UNITED STATES PATENT AND TRADEMARK OFFICE

APPLICATION NO.	FILING DATE	FIRST NAMED INVENTOR	ATTORNEY DOCKET NO.	CONFIRMATION NO.
10/760,228	01/21/2004	Kia Silverbrook	WAL05US	2203

Office Action Summary

DETAILED ACTION

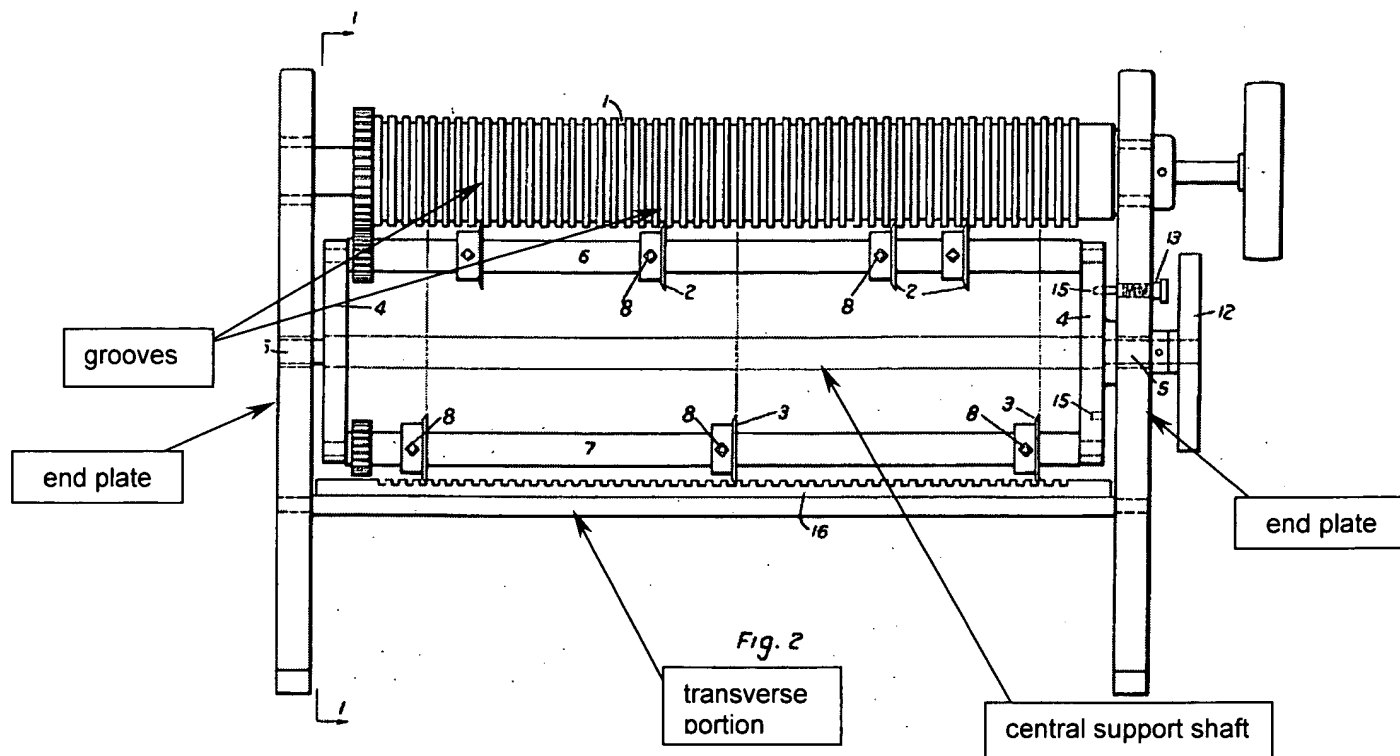
With respect to claim 1, Cameron discloses the claimed slitting mechanism except for the four rotating slitting shafts. Cameron et al. discloses a slitting mechanism including a chassis having end plates and a transverse portion as shown below in the Figure taken from Figure 2 of Cameron et al.:

Cameron et al. further discloses two rotating slitting shafts 6 and 7 extending between the end plates, each shaft having one or more slitters 2 and 3 respectively forming a rotating carousel arranged about a central support shaft. Each of the slitters have cutting edges as shown above. As shown above each slitter shaft 6 and 7 has at least one slitter 2 and 3, respectively, arranged along its length in a predetermined position different from those of the slitter of the other slitting shaft. The slitting mechanism can be selectively engageable to either enter or not enter a web path if a user so desires to move the above mechanism into or out of the path of a web. Although Cameron only discloses two rotating slitting shafts, the provision of two more rotating slitting shafts would have been obvious to one of ordinary skill in the art to provide more options of slitting spacing of the slitters.

roller above the path of the media as shown in Figure 2. Applicant is reciting a mere reversal of parts disclosed by Cameron. It has been held that reversal of parts would have been an obvious modification to one of ordinary skill in the art (In re Gazda, 219 F.2d 449, 104 USPQ 400 (CCPA 1955)). It would have been obvious to reverse the parts so that the slitter shafts 6 and 7 were above the guide roller 1 in order to make them more accessible for adjusting the slitters 2 and 3. Additionally, Cameron discloses that the guide roller has a number of circumferential grooves as shown in the Figure above; one slitter being associated with at least one groove.

With respect to claim 5, Figure 2 of Cameron shows that each shaft 6 and 7 is positionable such that each slitter 2 and 3, respectively enters a corresponding groove of the guide roller 1 when the selected shaft is rotated into a cutting position.
